UNITED STATES DEPARTMENT OF THE INTERIOR **BUREAU OF LAND MANAGEMENT**

1. Type of Well		mendens on page 2.	ROSA (JNIT	
Oil Well Gas V			ROSA U	Vame and No. JNIT #359A	
2. Name of Operator WILLIAMS PRODUCTION CO, LLC	С		9. API W 30-039-	'cll No 29939	
3a Address		3b Phone No. (include area	code) 10. Field	and Pool or E	Exploratory Area
P O BOX 640 AZTEC, NM 87410		(505) 634-4208	BASIN I	FRUITLAND	COAL
4 Location of Well (Footage, Sec., T.,	R, M, or Survey Description)		11 Coun	try or Parish,	State
Surface 465' FSL & 360' FWL, Sec 3, T31N, R5	W / BHL 900" FSL & 760' FEL, Sec	2 4, T31N, R5W	RIO AR	RIBA, NM	
12 CHEC	CK THE APPROPRIATE BOX	X(ES) TO INDICATE NATU	RE OF NOTICE, REPO	RT OR OTHE	ER DATA
TYPE OF SUBMISSION		Т	YPE OF ACTION		
	Acidize	Deepen	Production (Sta	rt/Resume)	Water Shut-Off
✓ Notice of Intent	Alter Casing	Fracture Treat	Reclamation	,	Well Integrity
Cubacquent Pagort	Casing Repair	New Construction	Recomplete		✓ Other ammended
Subsequent Report	Change Plans	Plug and Abandon	Temporarily Ab	andon

Operations Plan

Rosa Unit #359A

WELL LOCATION AND ACREAGE DEDICATION PLAT

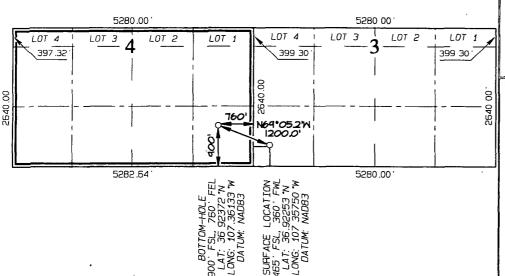
·	• ,					RCVD JUL 17 'O' OIL CONS. DIV	8
							DIST. 3	
Williams Production	, LLC. plans to ch	nange this well from a ho	rizontal drill to a	a directional cav	ritation as p	er attached plat, dire	ctional plan and drilling p	lan.
		OTIFY AZT			RS.		NS OF APPROV
